Prepared for: Weaver Models  
April 29, 2004

## Edited photo from Weaver Models .com

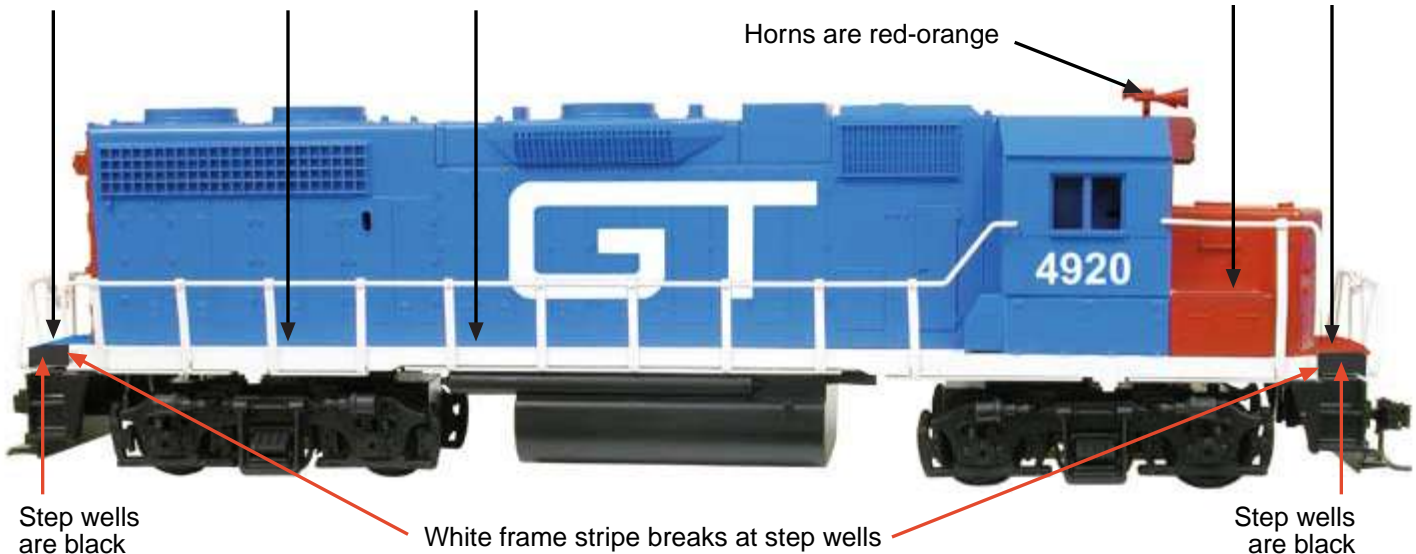
Walkway & deck all around long hood is blue

Walkway, steps & deck around front of cab are all red-orange

Horns are red-orange

Step wells  
are black

White frame stripe breaks at step wells

Step wells  
are black

Photos of custom paint done to GTW specs.

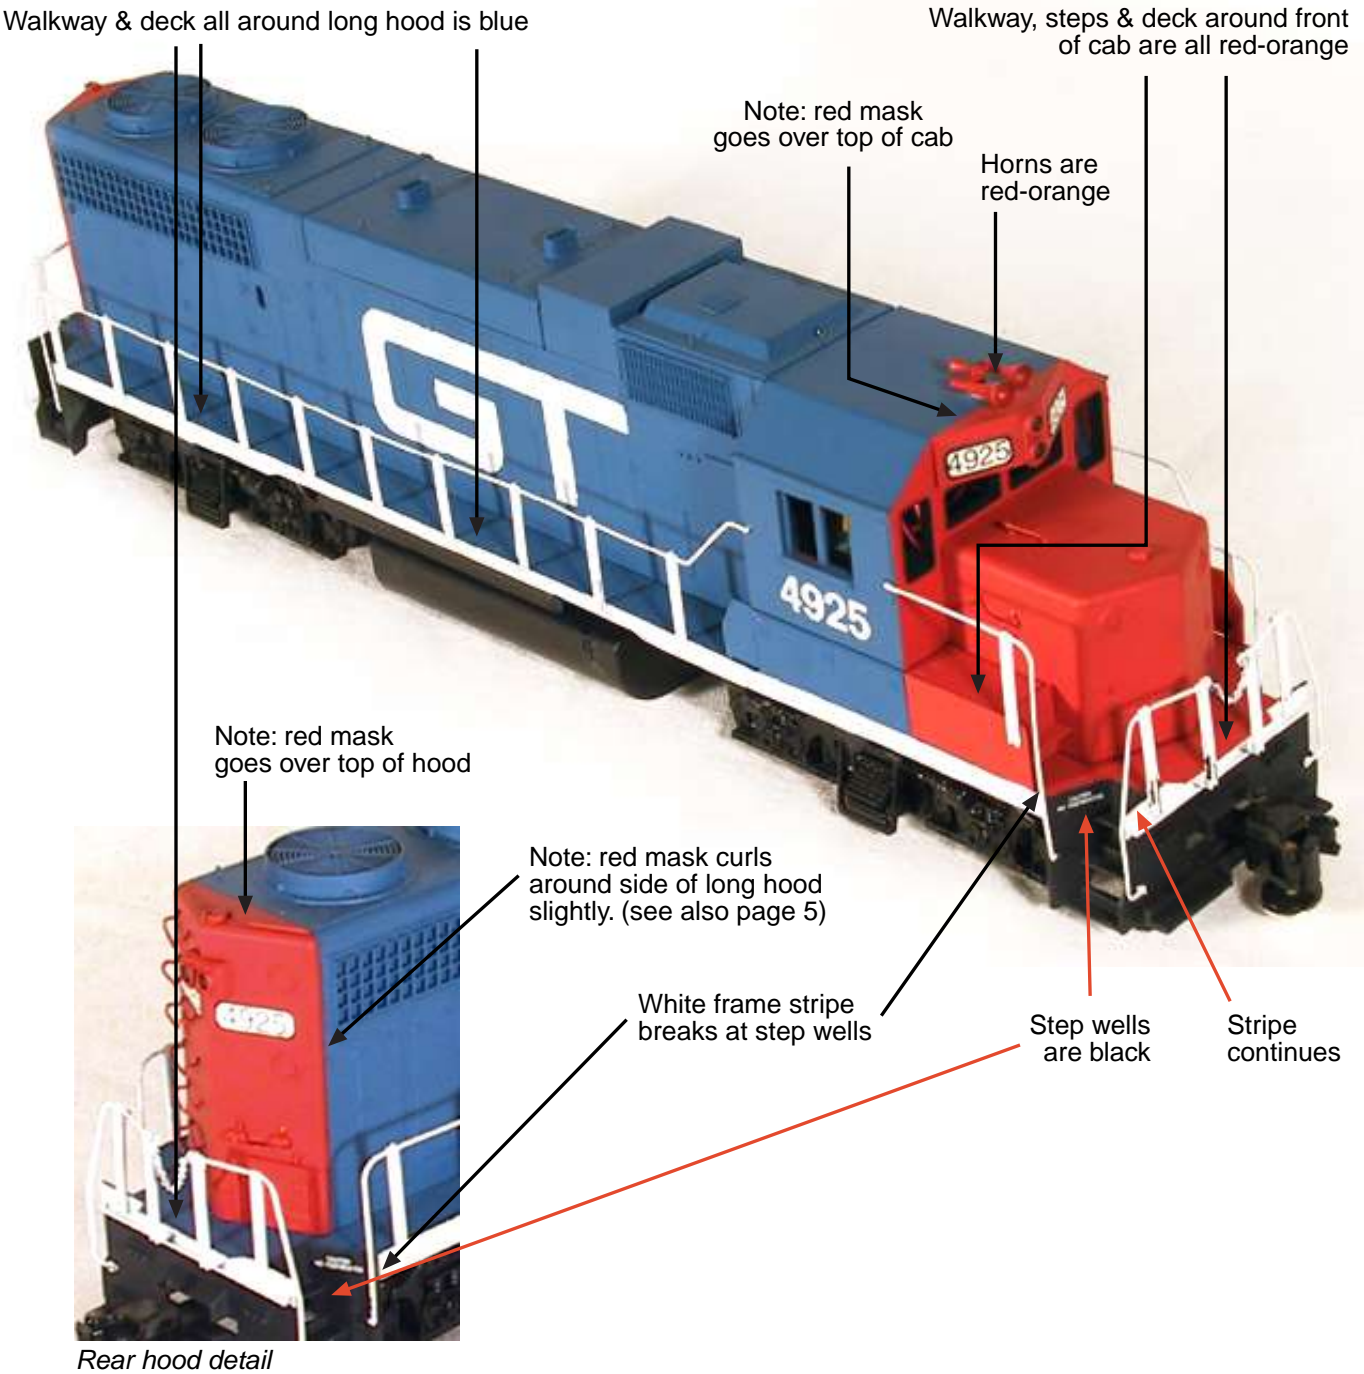
Your decision to use your Scalecoat Conrail Blue seems like a good compromise. The actual color is *slightly* darker and less “cyan” But these units tend to bleach out quickly, so this should work. If i had some actual color chips from your paint line, I could make a more accurate suggestion.

I believe the red you plan on using (Scalecoat Santa Fe Red) seems a bit to “pure red” to me. The actual color is a red-orange. See if your S2029-SP Scarlet or S2031-SP Daylight Red aren’t better choices. Don’t go *too* orange, it’s just a “warmer” red. The people in your paint dept. will be able to see something subtle like this. Your Scalecoat colors are very accurate and are spoken well of by many modelers I know.
